THE POINT - PHASES 8 AND 14

1 CID-24-01

CONSTRUCTION DRAWINGS - PACKAGE 3

V2 - CID-24-01 - Plan Set Part 1 of 2

PLAN AND PROFILE
GREENWAY "1", STA. 9+50 THRU STA. 22+00

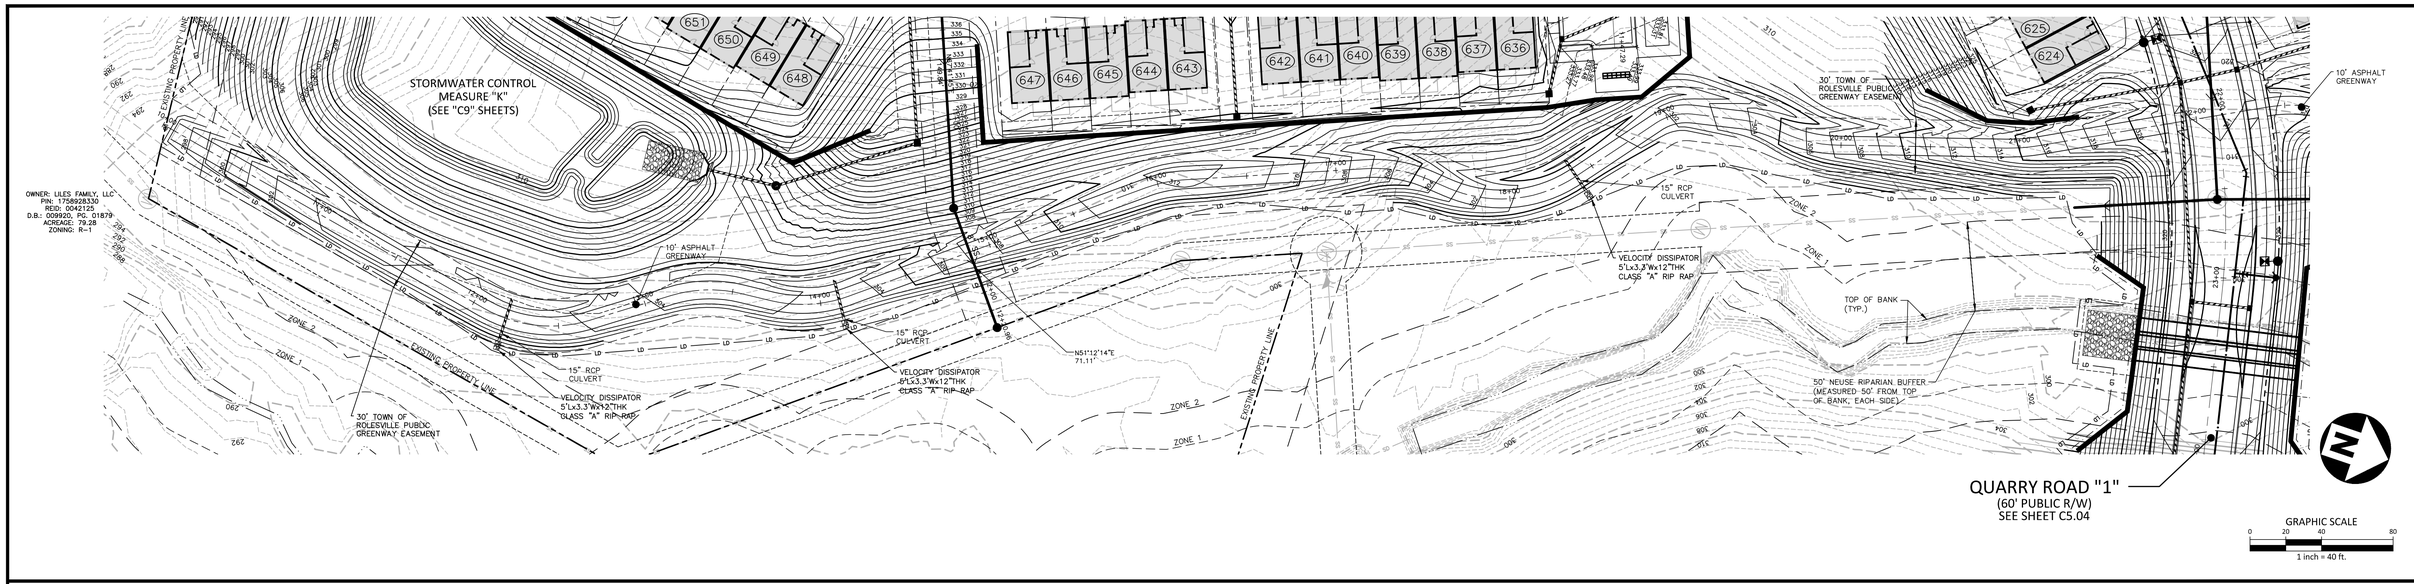
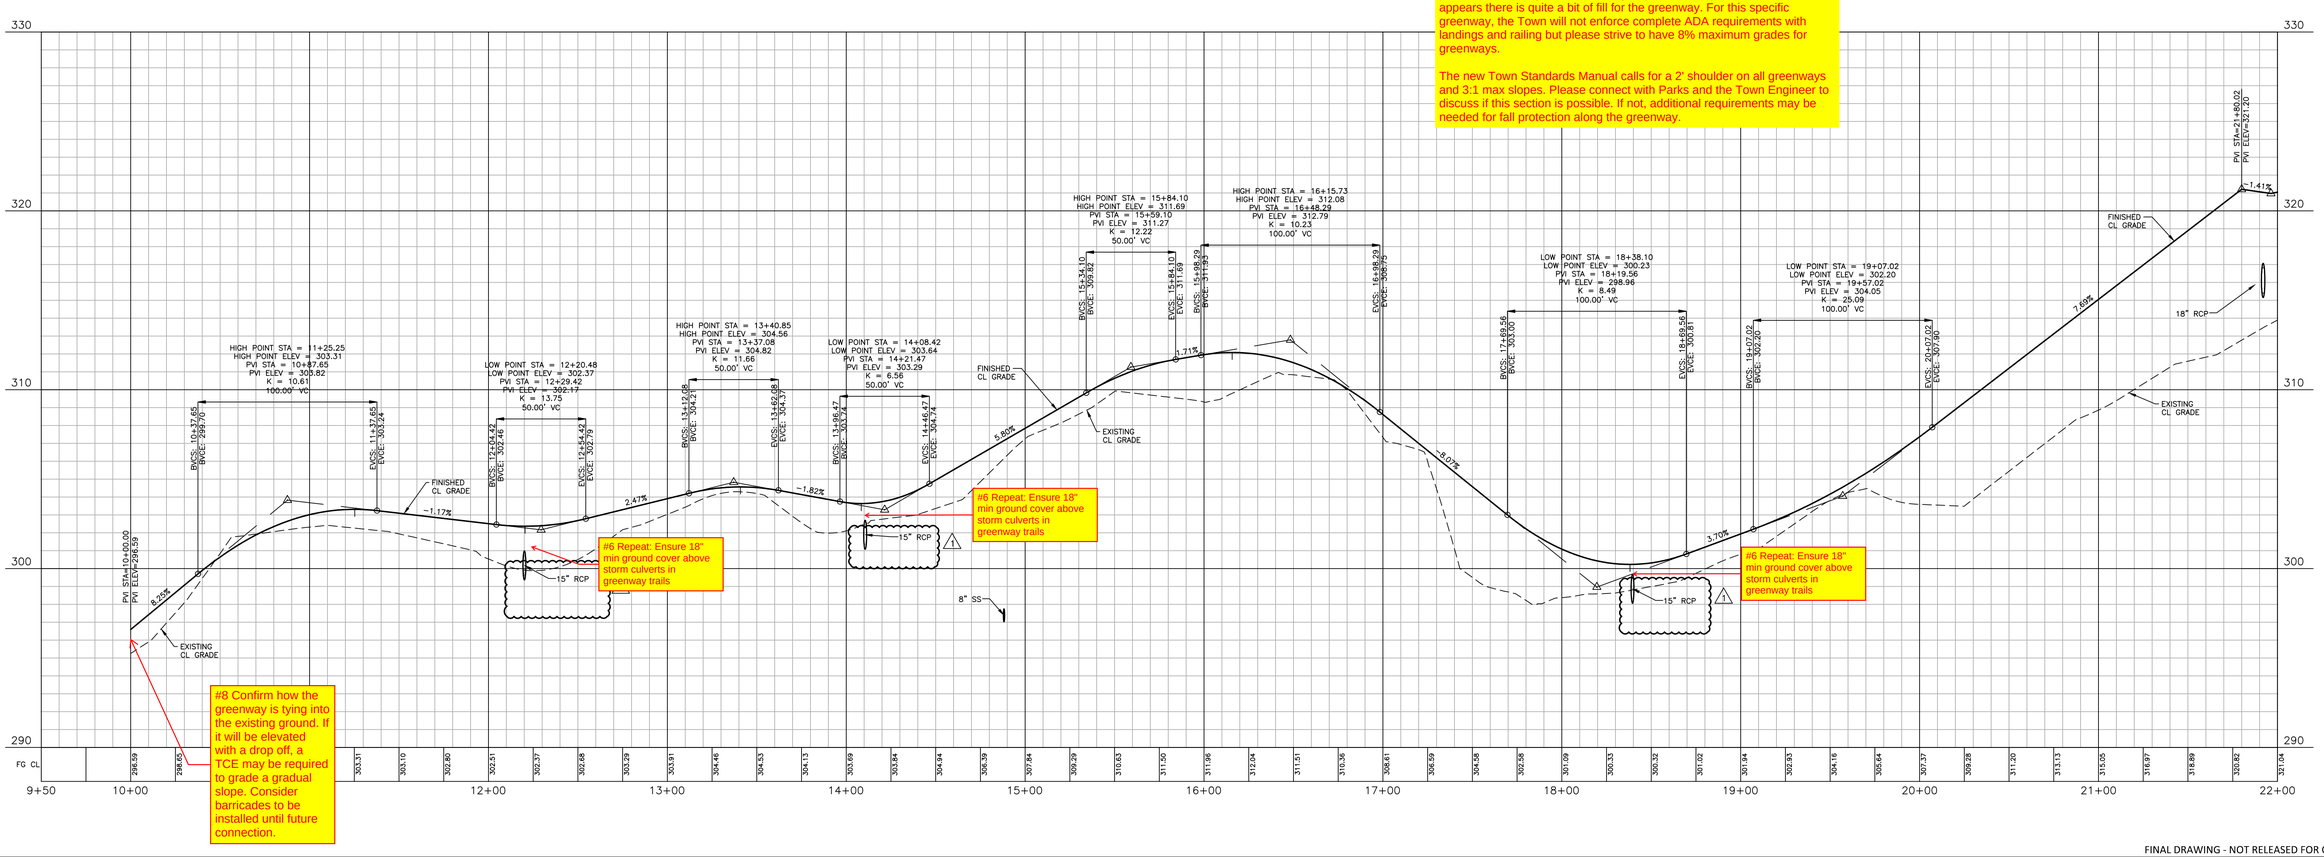
#7 The Town of Rolesville would like greenways to be ADA compliant if possible. We recognize the existing slopes are steep in this area, but it appears there is quite a bit of fill for the greenway. For this specific greenway, the Town will not enforce complete ADA requirements with landings and railing but please strive to have 8% maximum grades for greenways.

The new Town Standards Manual calls for a 2' shoulder on all greenways and 3:1 max slopes. Please connect with Parks and the Town Engineer to discuss if this section is possible. If not, additional requirements may be needed for fall protection along the greenway.

PLAN AND PROFILE
GREENWAY "1", STA. 21+50 THRU STA. 30+50

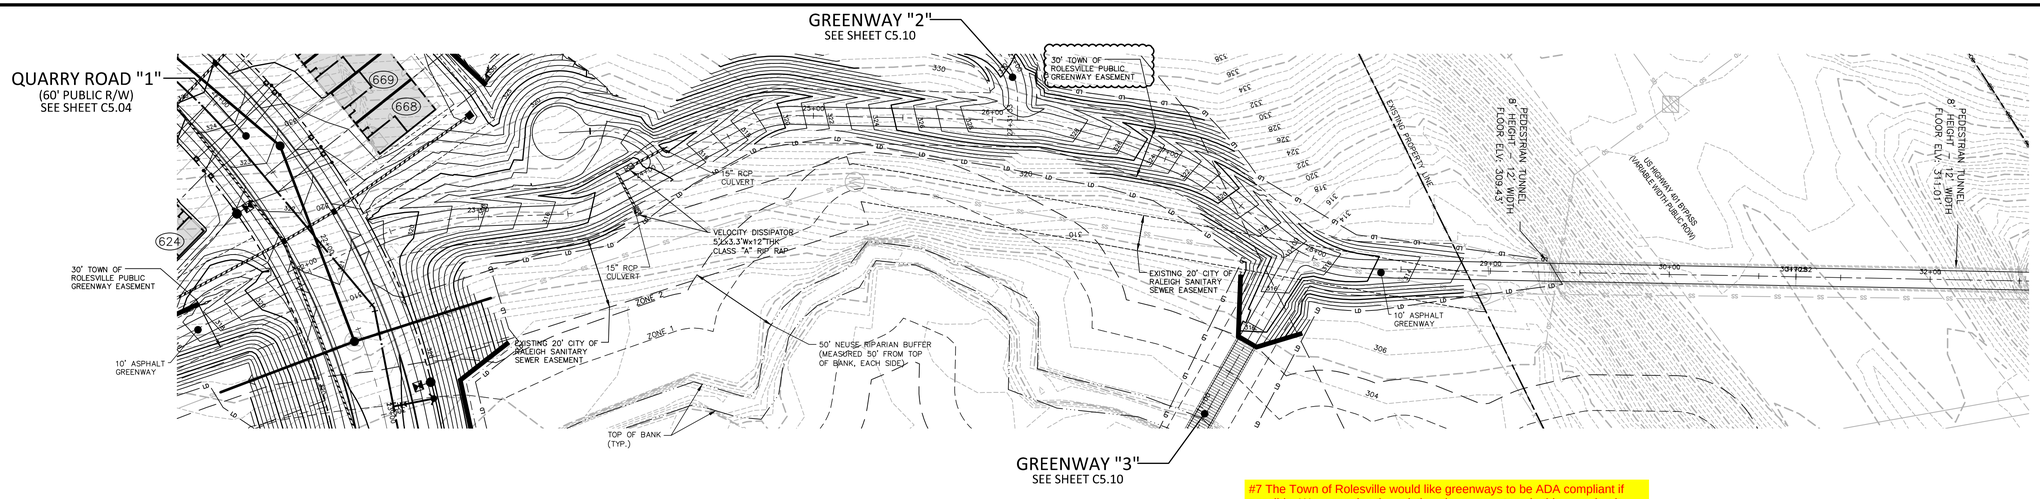
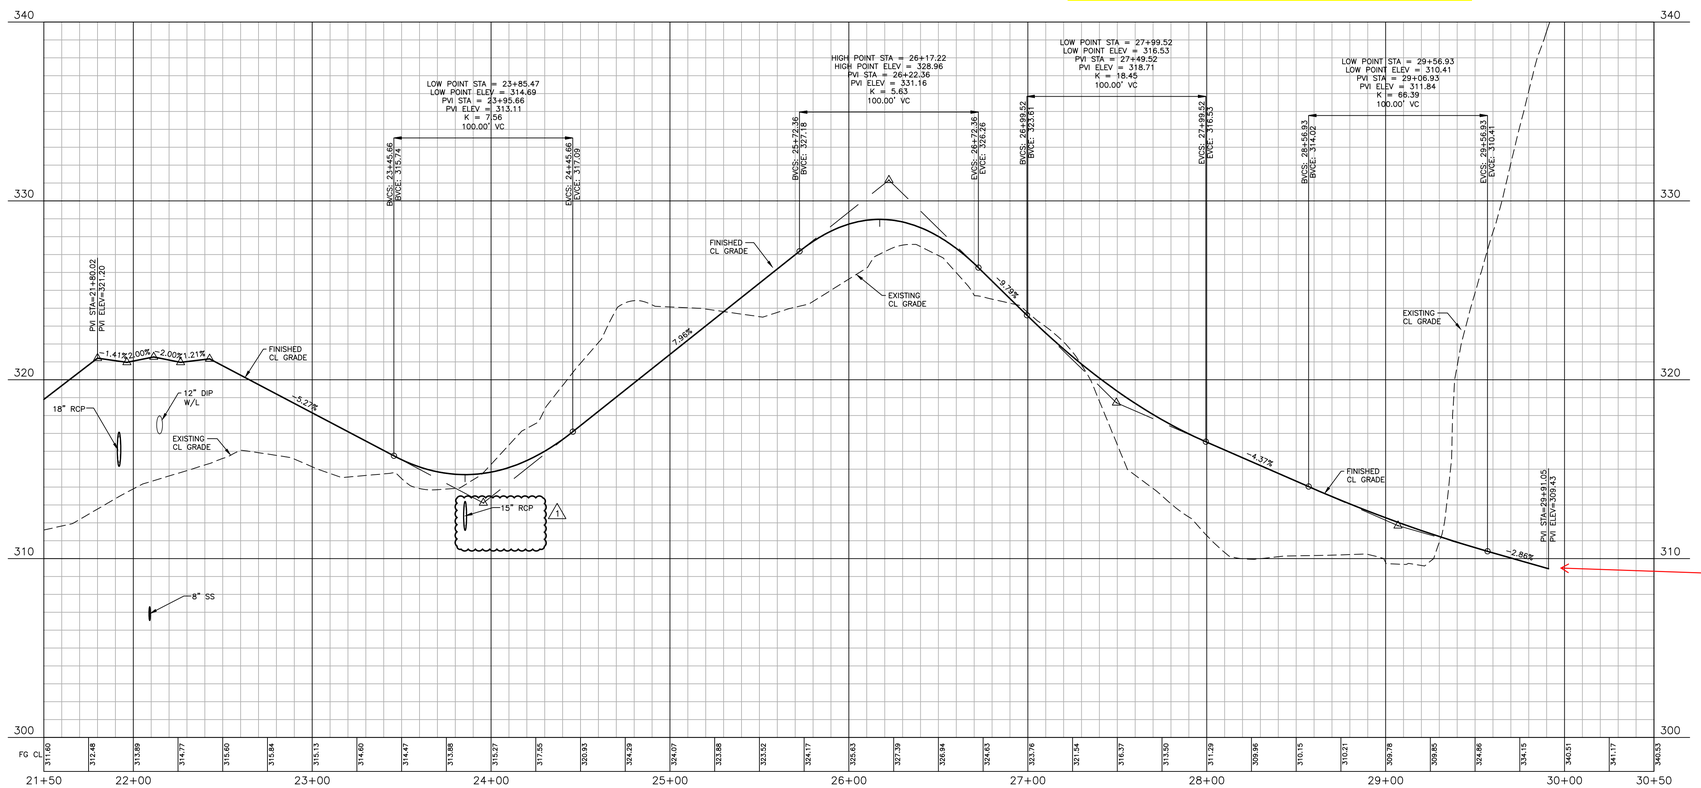
#7 The Town of Rolesville would like greenways to be ADA compliant if possible. We recognize the existing slopes are steep in this area, but it appears there is quite a bit of fill for the greenway. For this specific greenway, the Town will not enforce complete ADA requirements with landings and railing but please strive to have 8% maximum grades for greenways.

The new Town Standards Manual calls for a 2' shoulder on all greenways and 3:1 max slopes. Please connect with Parks and the Town Engineer to discuss if this section is possible. If not, additional requirements may be needed for fall protection along the greenway.

#9 The shading on plan view has been removed; please confirm if this profile is connecting into existing or if there is a structural design for the tunnel mentioned in plan view.

PLAN AND PROFILE
GREENWAY "2", STA. 9+50 THRU STA. 22+50

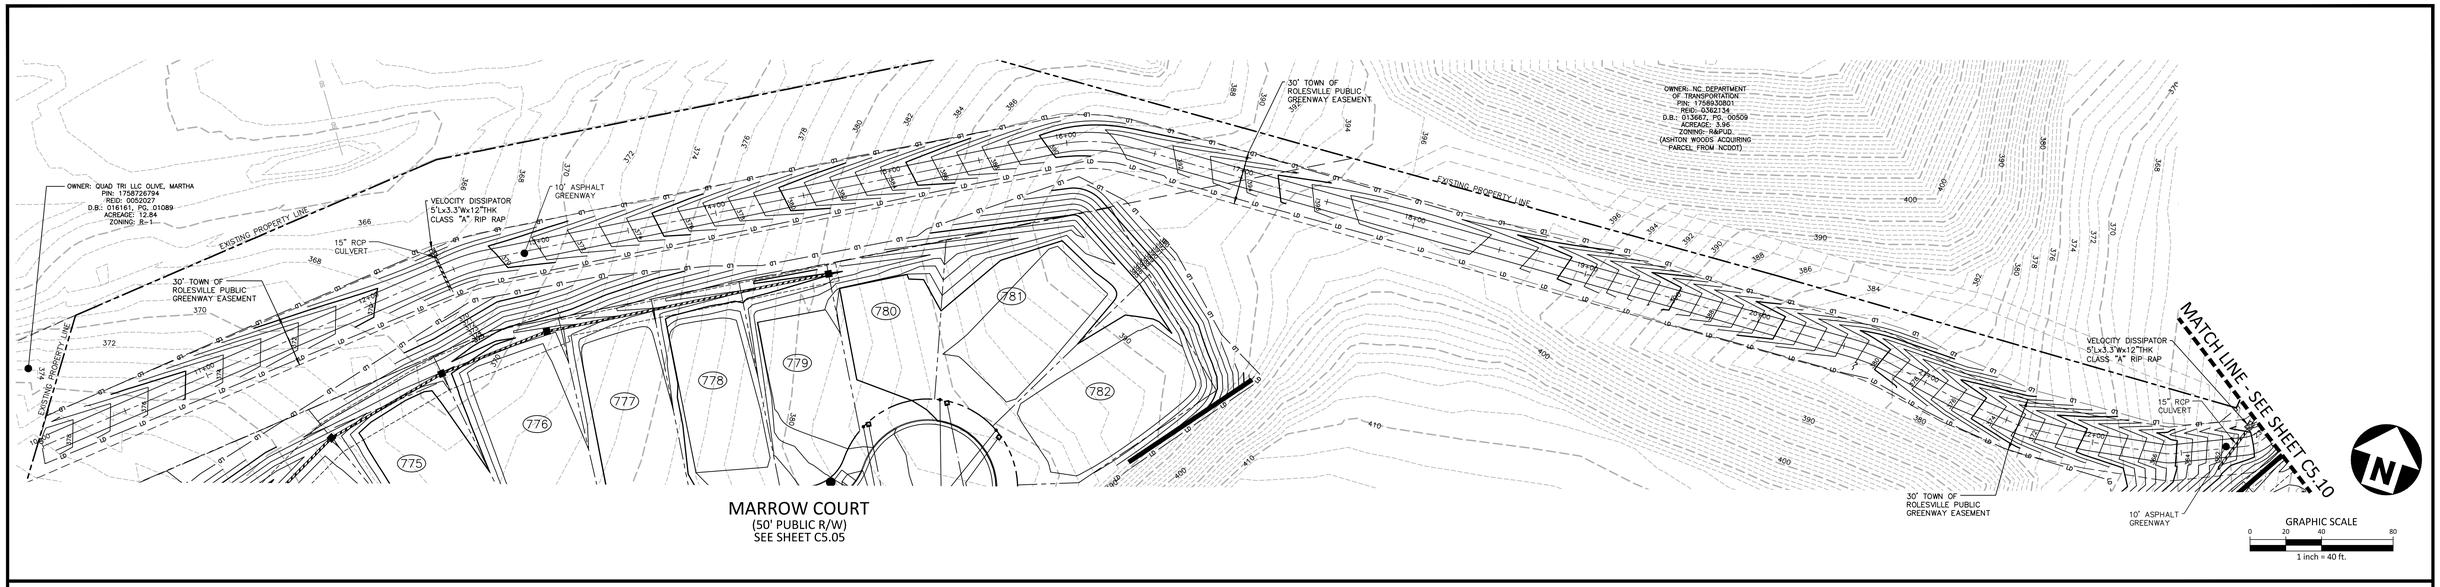
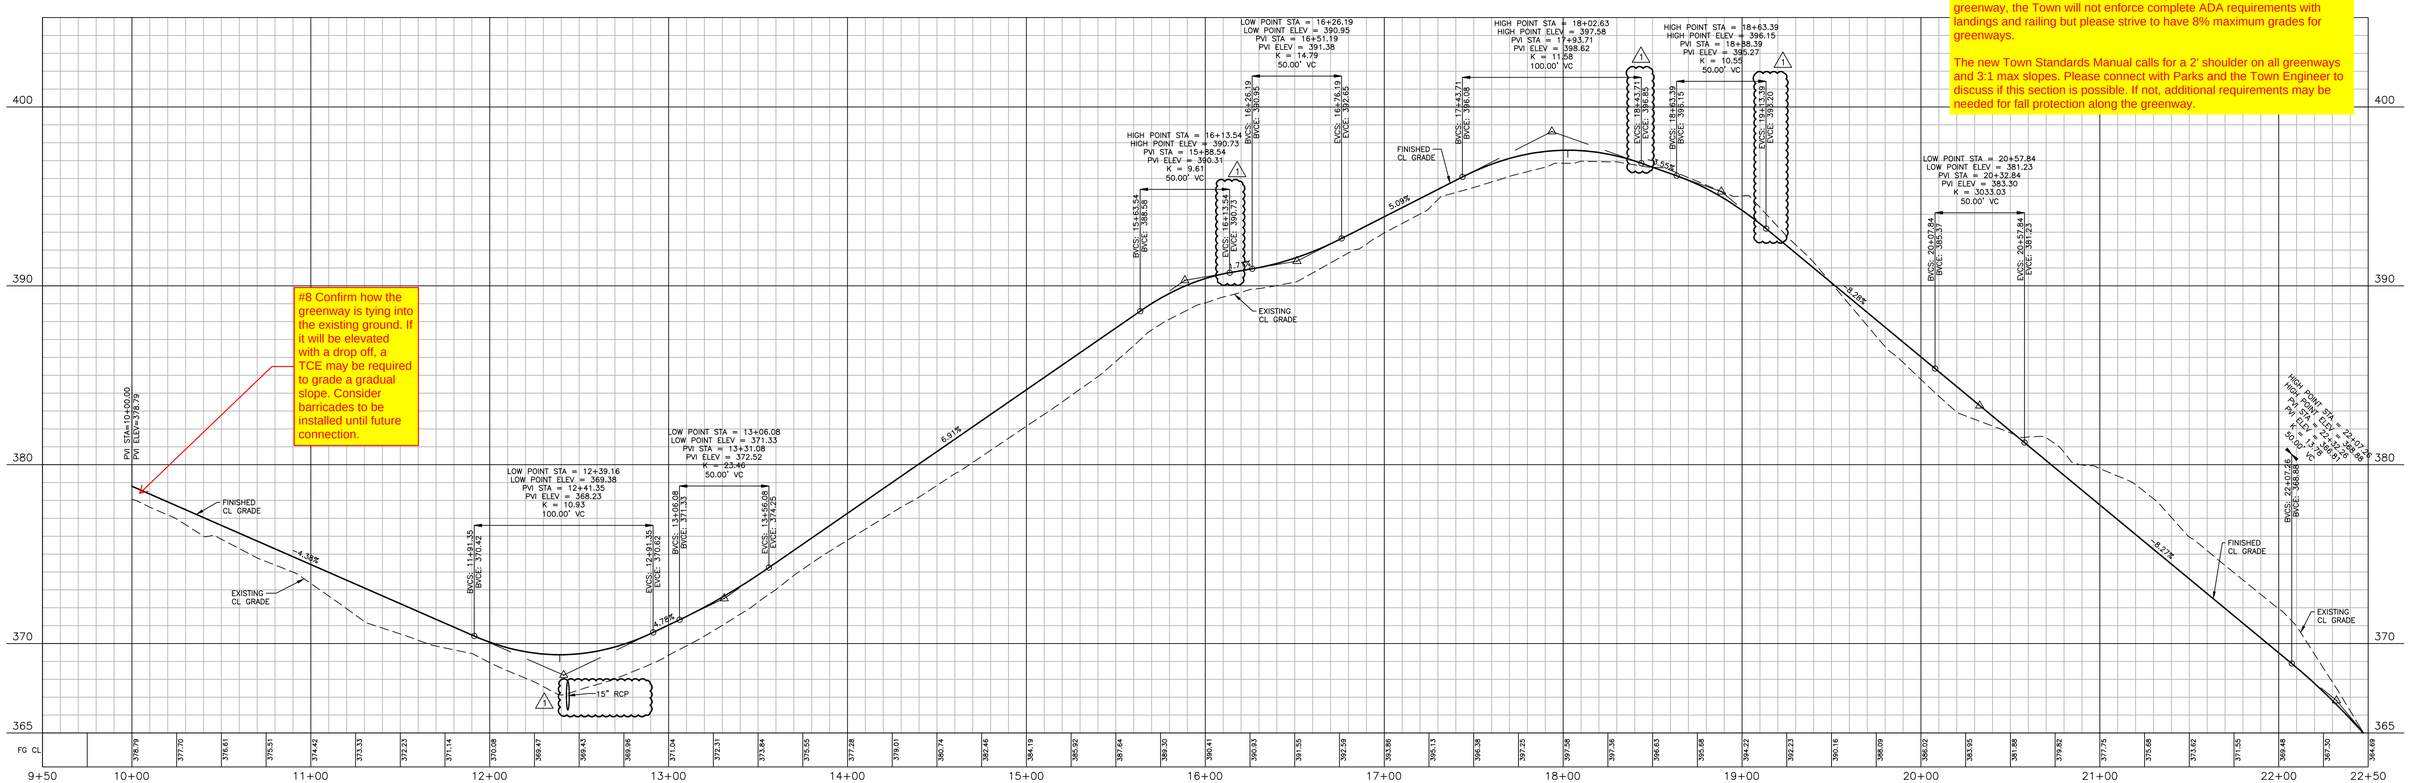
#7 The Town of Rolesville would like greenways to be ADA compliant if possible. We recognize the existing slopes are steep in this area, but it appears there is quite a bit of fill for the greenway. For this specific greenway, the Town will not enforce complete ADA requirements with landings and railing but please strive to have 8% maximum grades for greenways.

#8 Confirm how the greenway is tying into the existing ground. If it will be elevated with a drop off, a TCE may be required to grade a gradual slope. Consider barricades to be installed until future connection.

PLAN AND PROFILE
GREENWAY "2", STA. 22+50 THRU STA. 27+50
GREENWAY "3", STA. 10+00 THRU STA. 13+00

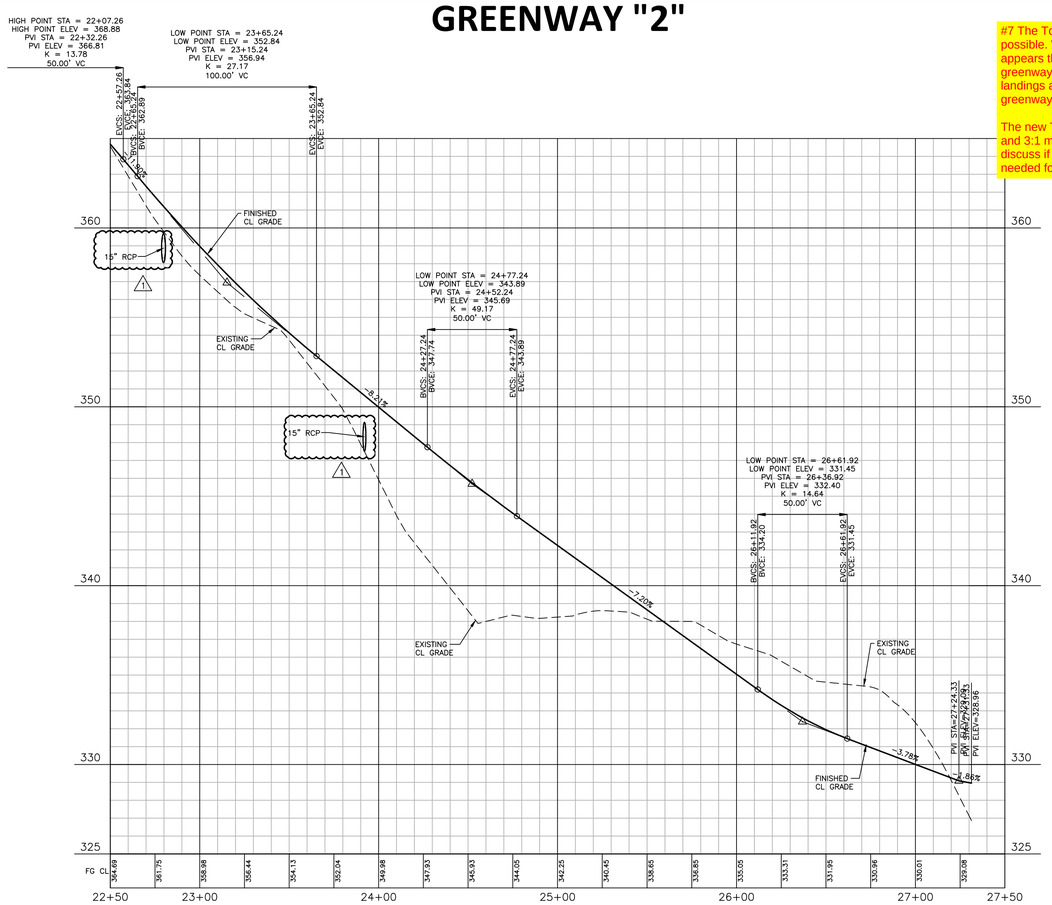
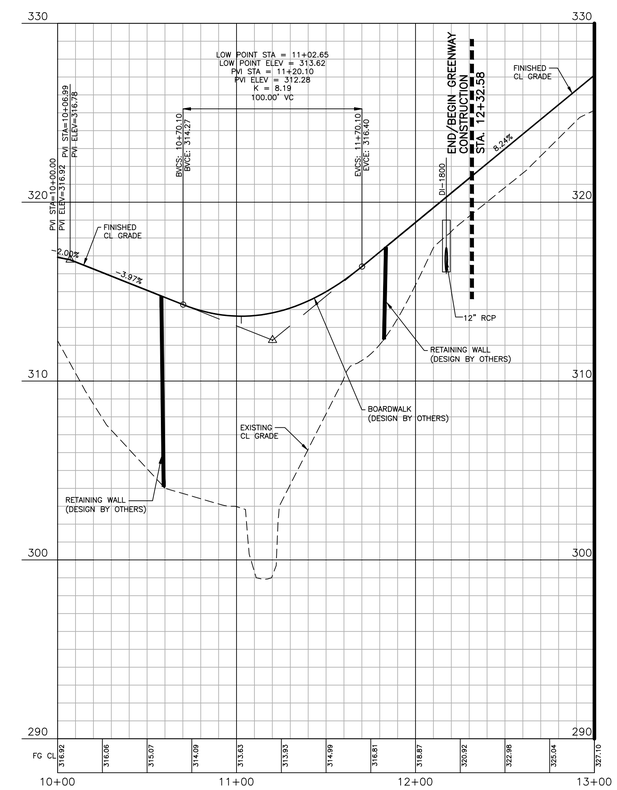
#7 The Town of Rolesville would like greenways to be ADA compliant if possible. We recognize the existing slopes are steep in this area, but it appears there is quite a bit of fill for the greenway. For this specific greenway, the Town will not enforce complete ADA requirements with landings and railing but please strive to have 8% maximum grades for greenways.

The new Town Standards Manual calls for a 2' shoulder on all greenways and 3:1 max slopes. Please connect with Parks and the Town Engineer to discuss if this section is possible. If not, additional requirements may be needed for fall protection along the greenway.
